REQUEST FOR PROPOSALS  
ENGINEERING DESIGN-BUILD SERVICES  
FUNDY DISCOVERY SITE BRIDGE CONSTRUCTION

**ADDENDUM #1**

April 17, 2025

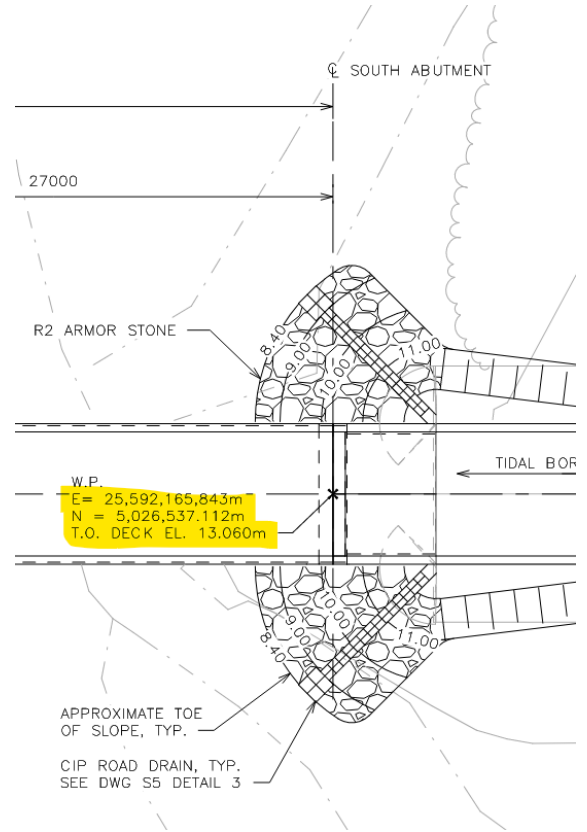
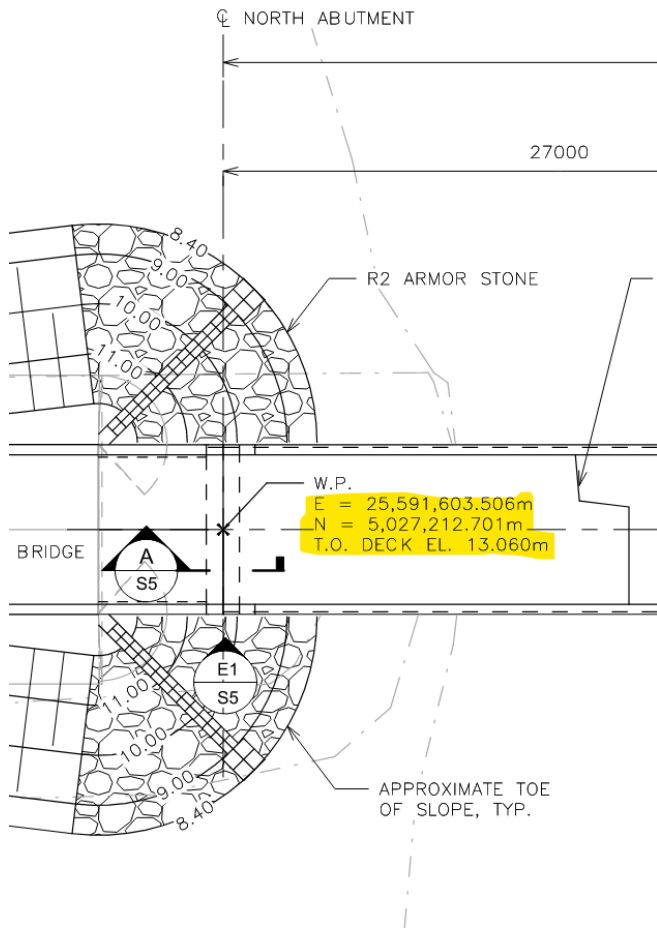
- A. Question: *Our designers have found that the Working Point (WP) coordinates on the drawing seem in error “the South abutment comes out north of the North abutment”. Can you confirm if the Work Points are correct?*

Answer: Yes, the Municipality can confirm that there was a typo, and the WP coordinates were “flipped” between the two abutments. See below for corrected coordinates
